This is to certify that PORTLAND MUSEUM OF ART / RE-ENTRY

has permission to Develop 45 space parking w/ Plant areas

Project Name: PMA parking lot and gardens

On May 27, 2008, the Portland Planning Board considered the Portland Museum of Art proposal for a 45 space surface parking lot and associated access, lighting and landscaping improvements on the site of the former YWCA on Spring Street. The Planning Board reviewed the proposal for conformance with the standards of the Conditional Use and Site Plan Ordinances.

PMA IDENTIFICATION SIGN
NOT TO SCALE

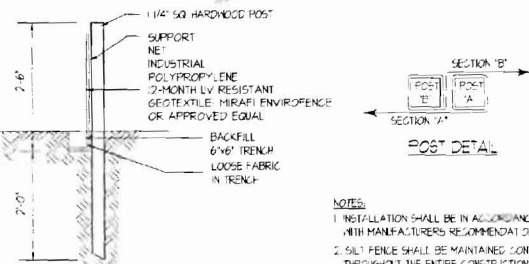
- iv. That any signs, including the proposed sign at the corner of Spring and Oak Streets shown in Plan 5.0, shall be subject to detailed review and approval prior to the issuance of a Certificate of Occupancy; and

1 FENCE AT CONCRETE RETAINING WALL AND STEEL TRELLIS (ALTERNATE #1): WEST SECTION

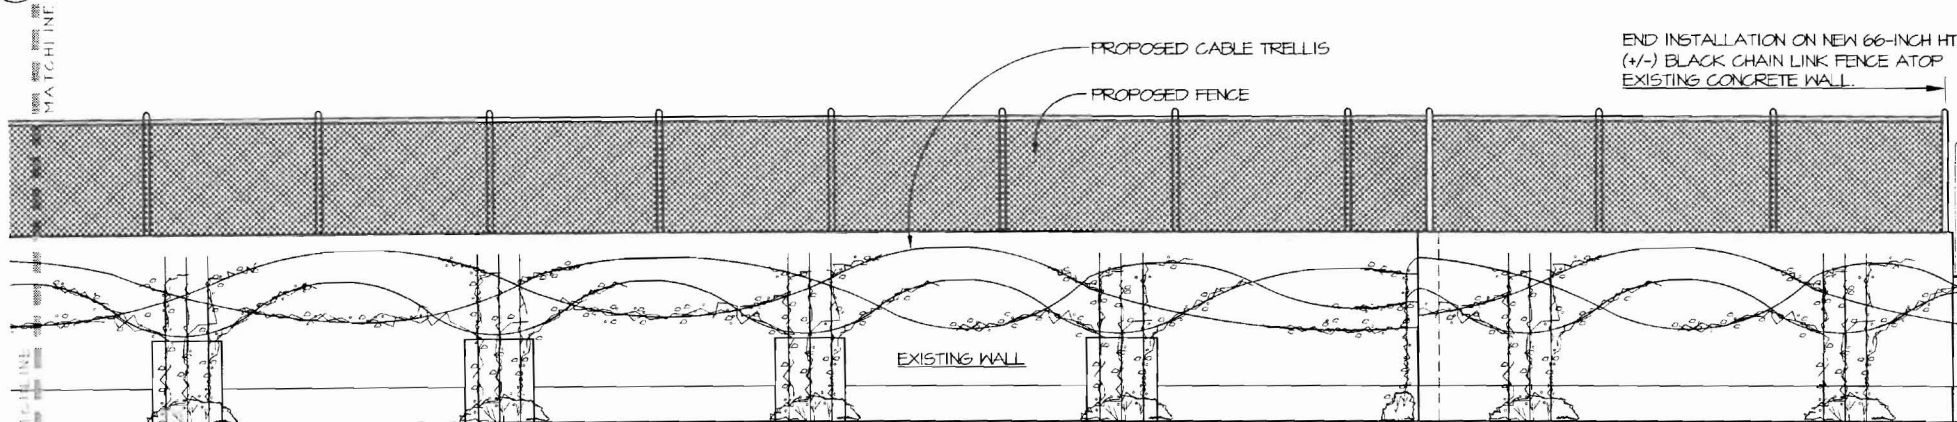
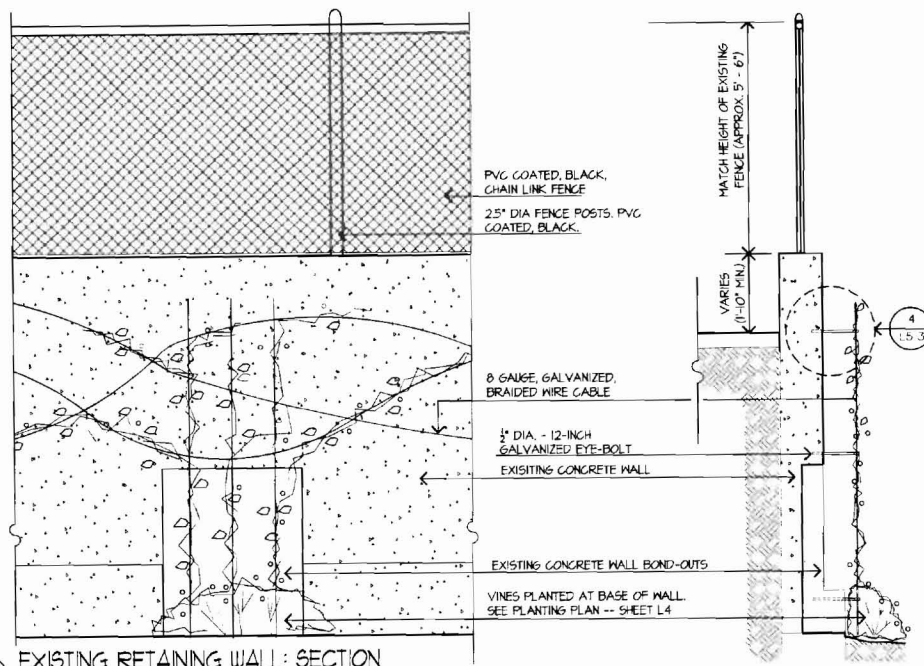
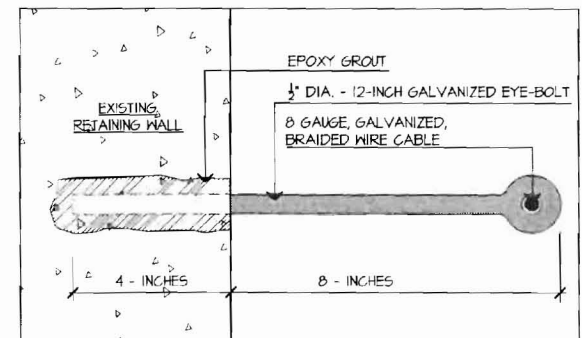
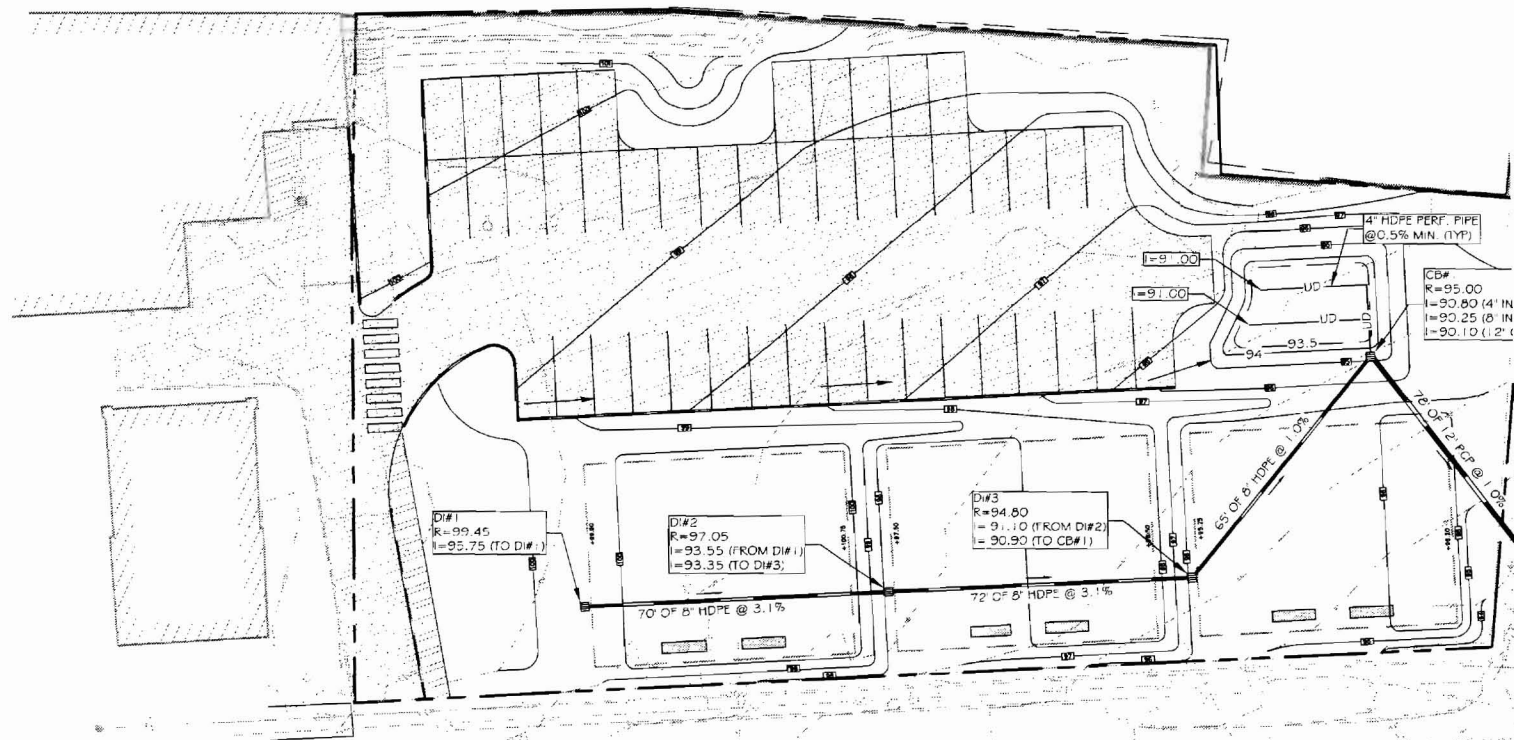
3. Treatment of the rear wall:
The information that was presented to the Board for the treatment of the rear wall has been included on a separate drawing, L5.3, submitted in this package. As presented to the Board, we will be installing cables on the rear wall as an armature for the vines. The layout and construction details for the cables are shown on the newly inserted project sheet.

- v. That the applicant shall revise the design of the central portion of the fencing along the top of the existing retaining wall to address the concerns of the Children's Museum of Maine, to be submitted for review and approval by the Planning Authority prior to the issuance of a building permit.

4 BIORETENTION CELL
NOT TO SCALE

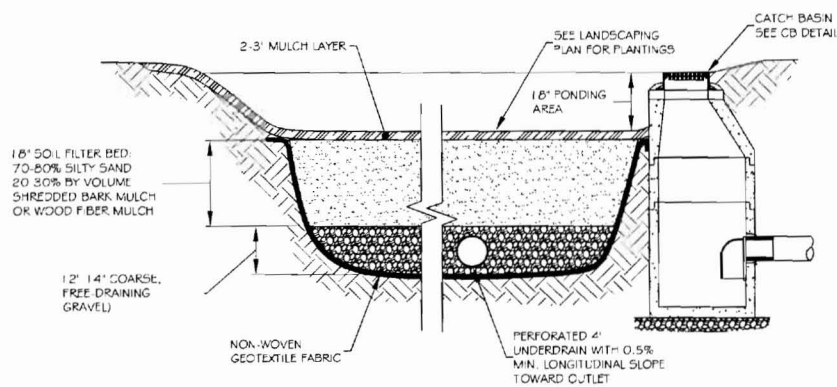
- ii. That the applicant shall be responsible for ongoing maintenance and monitoring of the operation of the bioretention cell/raingarden, and immediately address any problems that may arise (eg re survival of plantings, safety for the public), whether identified by the applicant or other parties, to the satisfaction of the Planning Authority; and
